SITE DRAINAGE AND ENCROACHMENT QUESTIONNAIRE

Re: Floor Joists
Mering Residence II
Sacramento, CA.

Per your request, CS Engineering is submitting this letter in response to the proposed framing modifications at the subject project. In particular, I shall address ceiling joist elimination.

FIELD MODIFICATION @ MERVING RESIDENCE

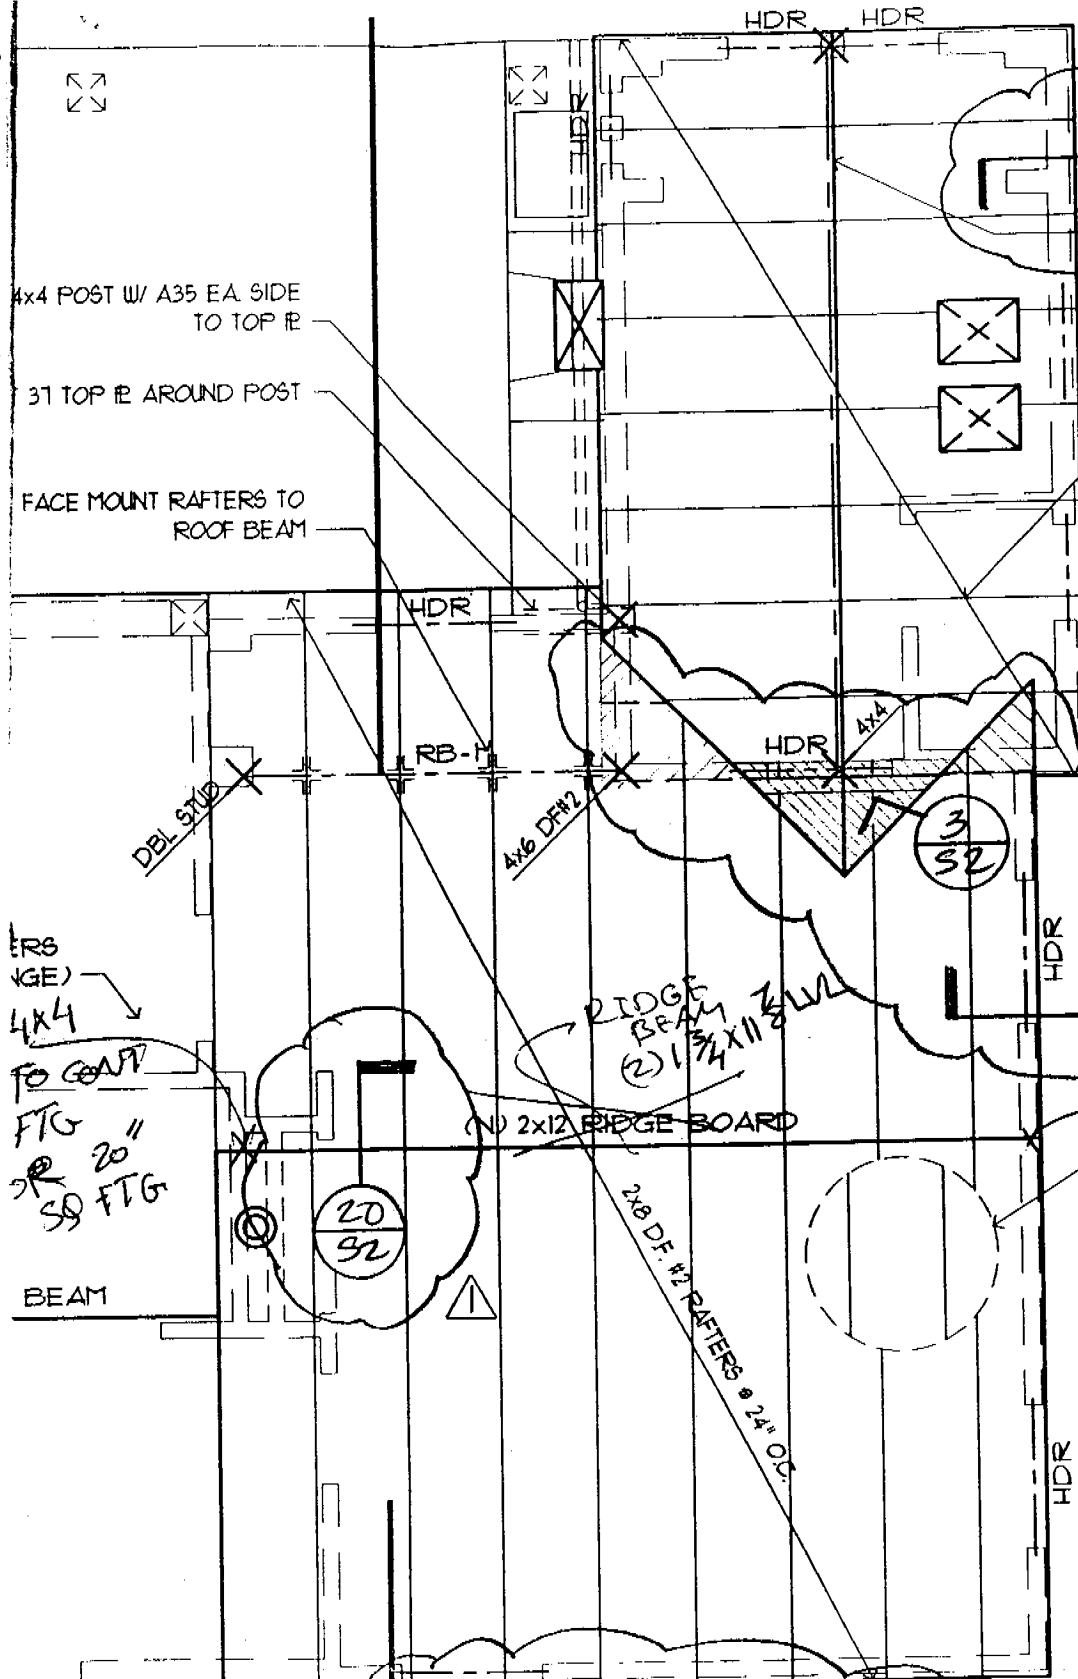
It is my professional opinion, based upon a review of the drawings and calculations, that the proposed framing modifications are structurally acceptable as long as the following criteria are met:

- Eliminate ceiling joists & use ridge beam (2) 1 3/4 x 11 7/8 LVL w/4 x 4 posts to continuous footing. See attached detail.
- At gable end provide wall stability by extending each stud and the (N) 4 x 4 post to the (E) roof rafters. Notch the old clg level top plate to pass studs. This is required between windows only.
- Due to Arch'l windows, the specified 5'-5" wall is only 48". Using same S.W. designation (#6) note that 48" is acceptable. See attached calculations.

LN B+A.6 REPLACE REMOVED CORNER BRACED WALL PANEL WITH FRAMED $\diamond 6$ WALL
 TOTAL WALL LENGTH = 8.5'

4x4 POST W/ A35 EA. SIDE TO TOP PL

FACE MOUNT RAFTERS TO ROOF BEAM

RIDGE BEAM 1-3/4x9-1/2 LVL

RIDGE BEAM (2) 1-3/4x11-1/2 LVL (N) 2x12 RIDGE BOARD

NOT NEEDED!
